Subject: Arroyo Vista Median Swale

INSPIRATION SUBDIVISION
PROPOSED BASINS MAP

ARROYO VISTA MEDIAN SWALE
(INTERIM CONDITION WITH
ONLY NORTH SIDE OF
ROADWAY BUILT)

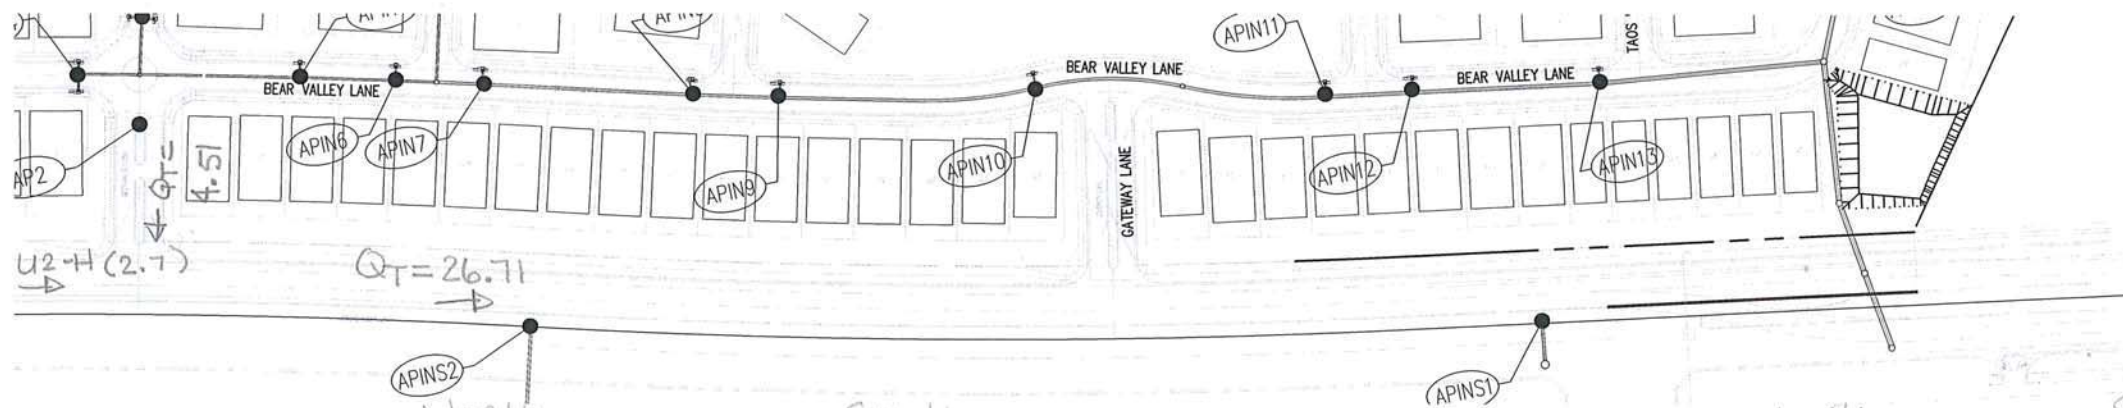
2. From a site visit it appears that 2/3 or so of Basin OS-2 drains to Basin U2-H before entering Arroyo Vista Blvd ROW. Grades were altered during wall construction, so existing grades cannot be used. In addition, the land was driven/worked on. Please update the basin calcs to 2/3 of 1.36 acres= 0.9 acres and use 100% Type C land treatment. In addition, Basin OS-2 should be broken up into two basins as there are two outfall locations. This would also allow for an "Arrow" showing the outfall location through Basin U2-H.

4. For Basin OS-1, move/point the flow arrow so that it is clear that this basin drains to the arroyo located south of the Arroyo Vista Blvd ROW.

After a site visit, I disagree that 2/3 of Basin OS-2 gets to Arroyo Vista. I stand by my revised calculation that 14% of OS-2 drains to Arroyo Vista with the remaining portion draining over the walls and into the subdivision. However, the 2/3 portion was calculated along with the 14% and are listed below. I have added the 2/3 of Basin OS-2 of 2.6cfs to the inlet location downstream and the inlet can still accommodate this additional 2.6cfs. See enclosed revised exhibits enclosed.

Flow arrow was previous shown just to light. it has been updated to remove previous arrow and darken new arrow

* REVISION 10-6-2022

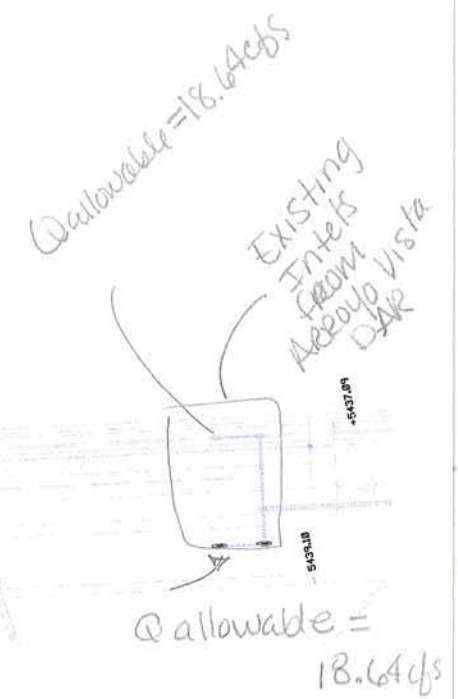
1. Per the DPM Figure 6.9.9, the capacity of a double inlet at 0.7' of depth at 0.2% slope is 10 cfs. The submittal states there is 29 cfs. The inlet appears to be undersized. The city does not count the 'throat' for its inlet capacity as is it there in case the grate plugs, which happened during the storm event referenced above.

3. Update the calculations for the inlet at the east end of the swale with the revised flow rate.

The information you provide is for an inlet that is on-grade. We are in sump condition. The inlet is sized adequately in sump. We prepared a side weir calculation that indicated 16' of width of curb needed to be removed to pass the flow into the location of the sump inlet. I have attached the submittal and approval to this letter.

See response above and exhibits enclosed.

North
 $Q_{100} = U2-H (2.7)$
 $U2-O (.8)$
 $Bear Valley (3.71) (AP2)$
 $AR-6 (8.5)$
~~15.71~~ **8.3**
~~15.51~~

*** 2.6 cfs**
18.11 cfs

*** 31.59 cfs**

*** REVISION 10-6-2022**

Inlet Schematic 7

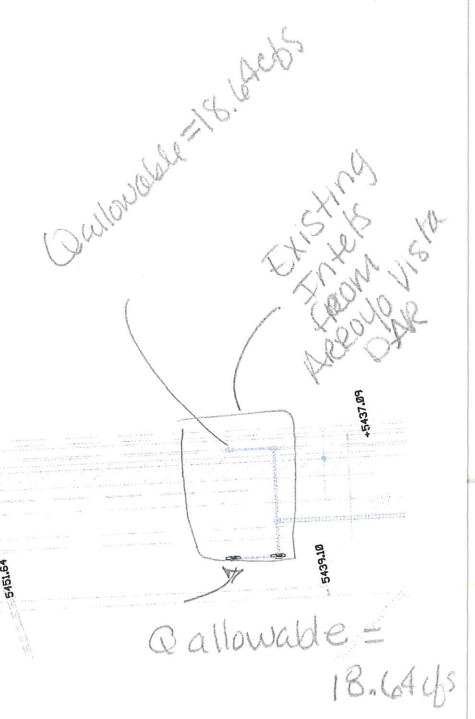
I have been looking at this and could you possibly see if you can darken up sheet 2 of the package you sent. I have had a hard time reading the handwritten notes on there. I am inclined to allow this but I want to make sure I have all the info laid out.

This is good. Much better. I had looked this over and I am giving Hydrology approval of this.

Hi Ernest. Is this better? I can try again if you want it darker still.
